5 JULY, 1991

BULLETIN.010

WIREFEEDER: W17 W16-21 MOTHERBOARD PCB

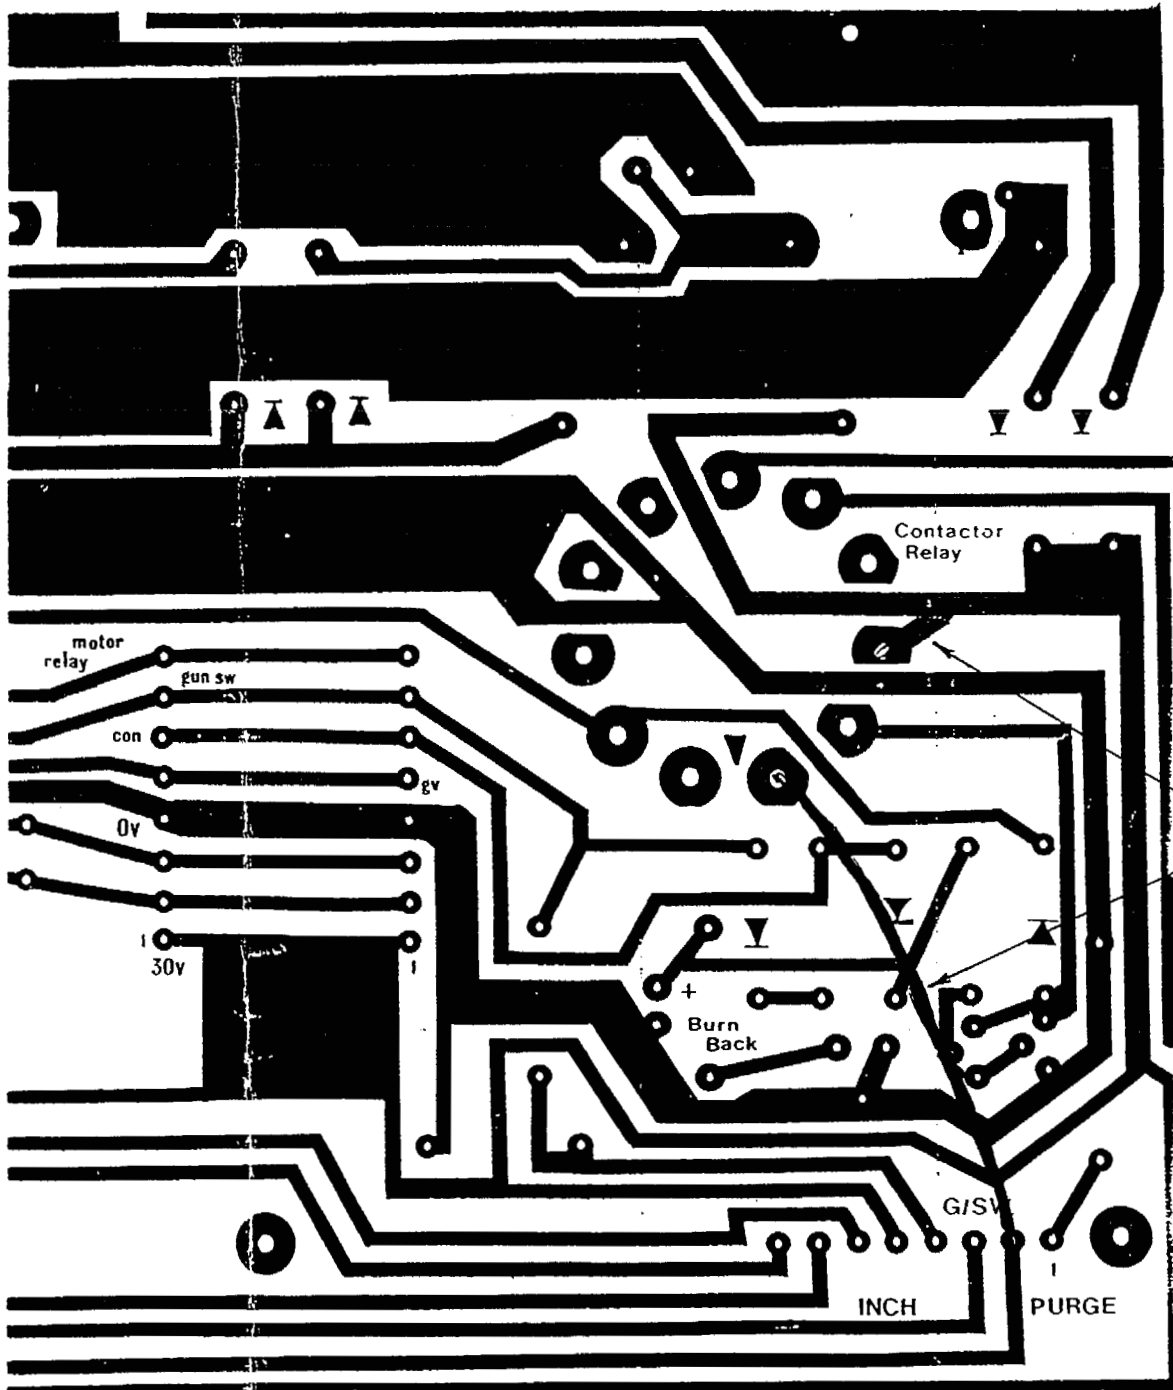
If problems appear at the end of a weld due to the lack of some post-flow gas, the W16-21 motherboard can be modified to connect the gas valve to the contactor burnback circuit, enabling a slightly longer period of gas operation.

Pin 2 and P1 should be connected to the +ve rail via a normally-open set of contacts on the K2 contactor relay.

Mod to connect Purge to B/Back control pot. time
Gives slightly extra time of Post Flow.

Add links.
